Statement No.

000594

**STATEMENT TO AMEND CONDITIONS APPLYING TO A PROPOSAL
(PURSUANT TO THE PROVISIONS OF SECTION 46 OF THE
ENVIRONMENTAL PROTECTION ACT 1986)**

**DESALINATED WATER AND SEAWATER SUPPLIES PROJECT
BURRUP PENINSULA, SHIRE OF ROEBOURNE**

Figure 2: Pipeline Route (Source: Burns & Roe Worley)

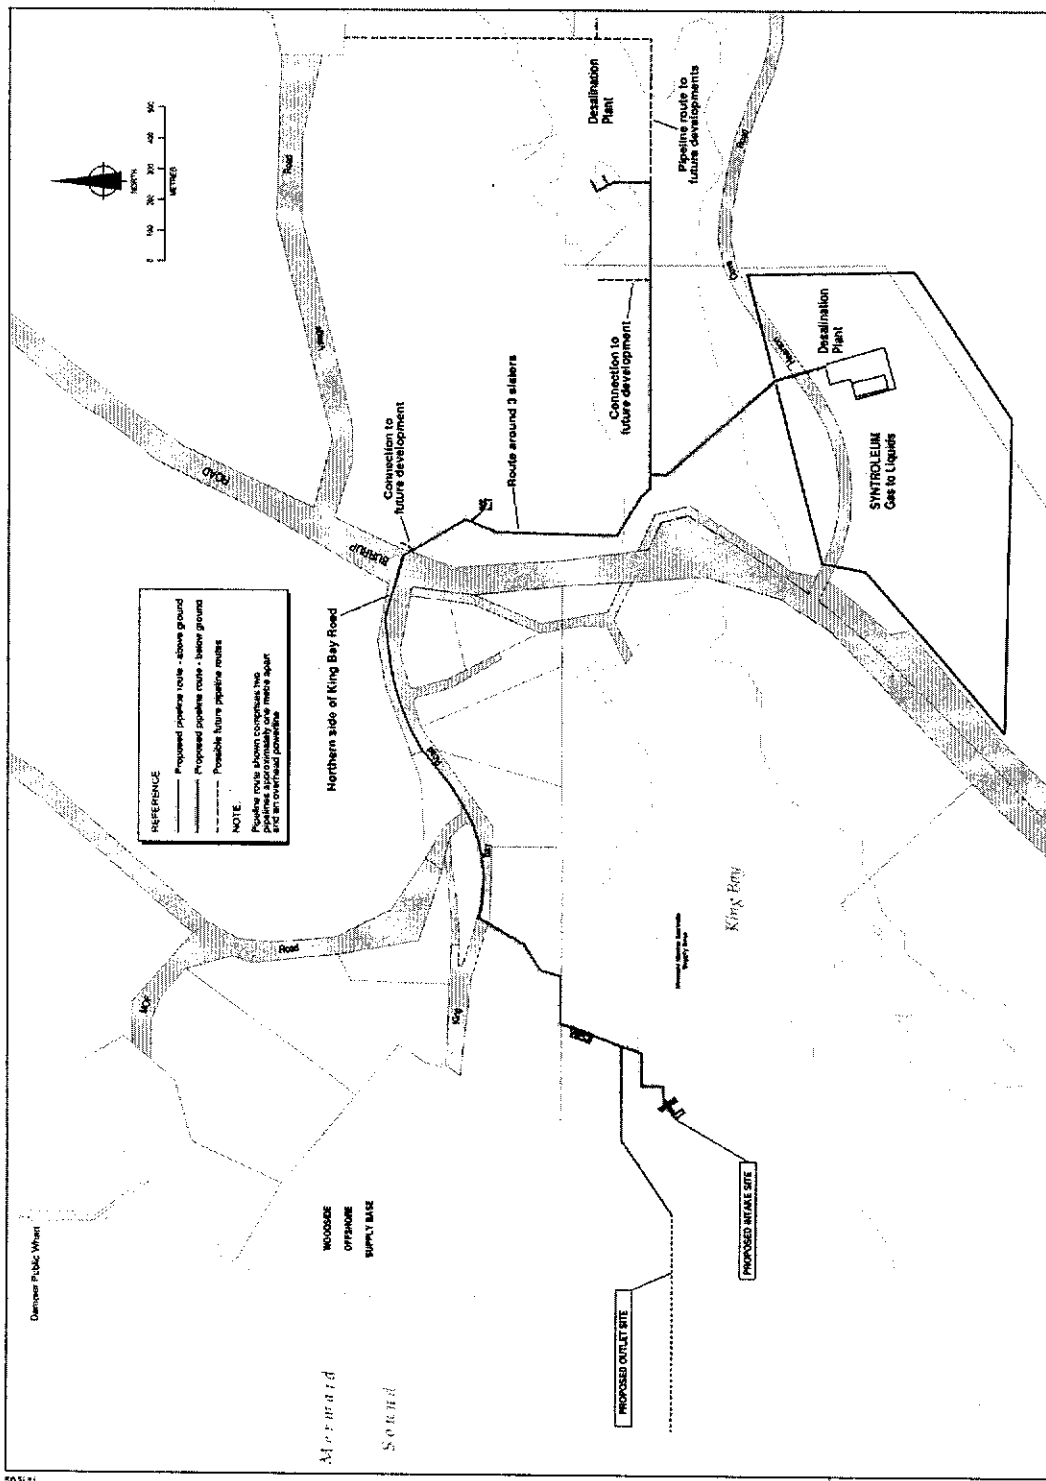
The pipeline route and location of the seawater inlet and brine outlet are shown in Figure 2 (attached).

Figure 1: Desalinated Water and Seawater Supplies Burrup Peninsula Development Envelope and disturbance footprint.

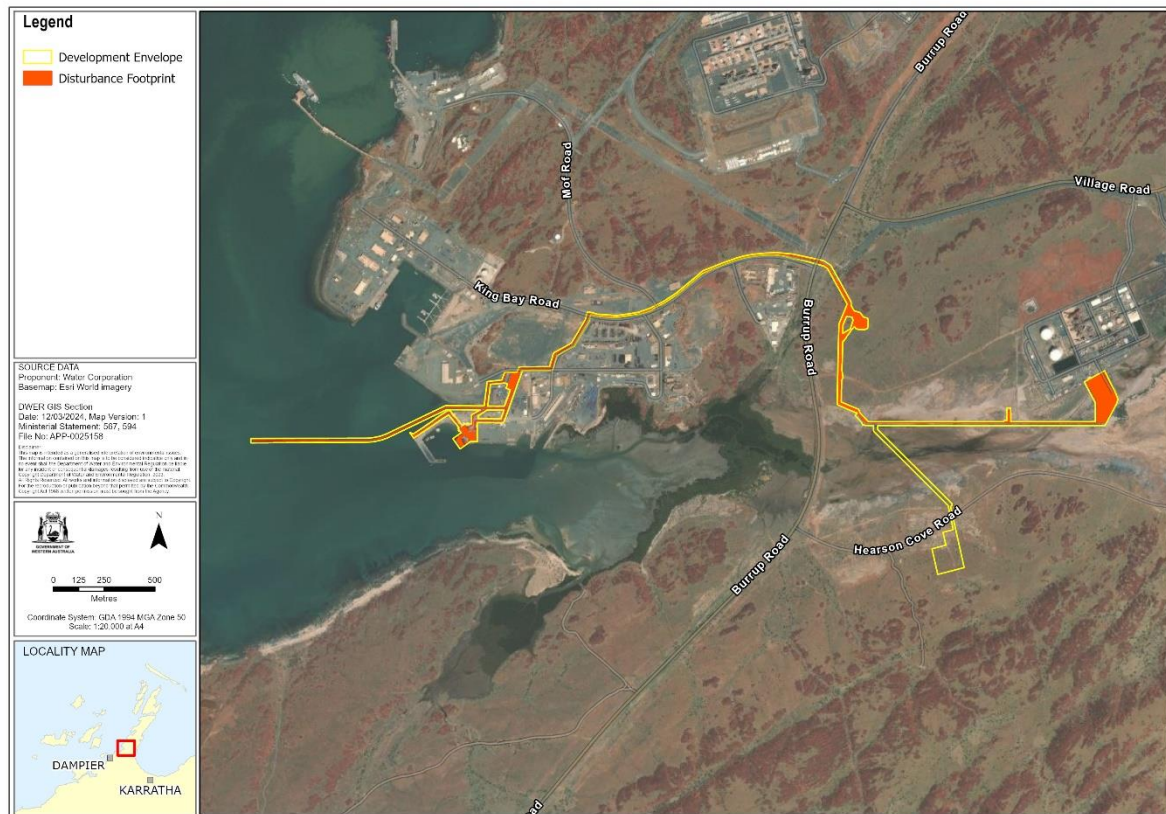
Changes:

- Define the development envelope using spatial coordinates (Replace Figure 2 of MS 594 with defined development envelope in schedule 3 (new))
- Increase development envelope by 1.44 ha, from 17.96 to 19.40 ha
- Increase in clearing by 0.26 ha, from 6.36 to 6.62 ha
- Delete in Table 2 the element Operational Noise, and description: Seawater intake system: "less than 70 dB(A) at 1 metre from pump well".

Figure 1: Desalinated Water and Seawater Supplies Burrup Peninsula Development Envelope and disturbance footprint. (This replaces Figure 2 of MS 594)

Figure 1: Desalinated Water and Seawater Supplies Burrup Peninsula development envelope and disturbance footprint.

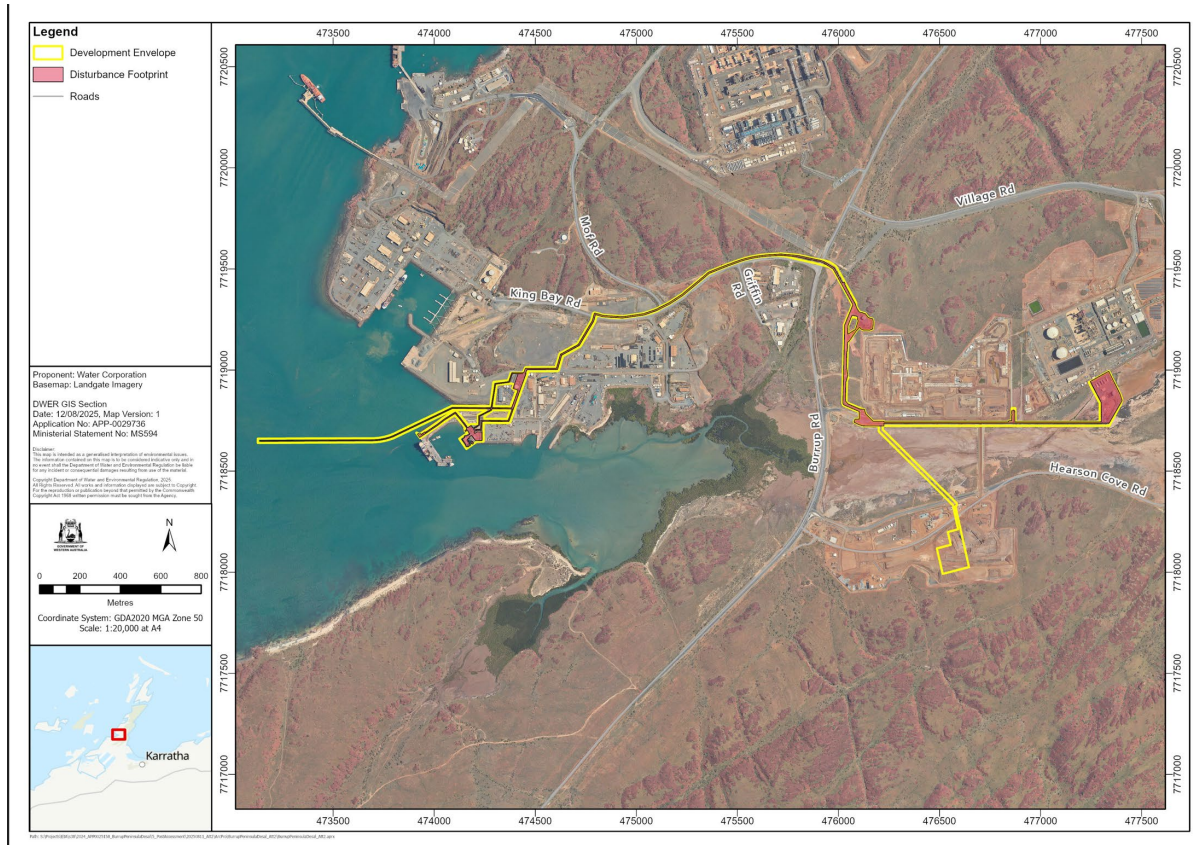
Changes:

- Increase the development envelope from 19.40 ha to 19.63
- Increase the disturbance footprint from 8.23 ha to 8.65 ha

Figure 1: Desalinated Water and Seawater Supplies Burrup Peninsula Development Envelope and disturbance footprint (this figure is a representation of the coordinates referenced in Schedule 3).
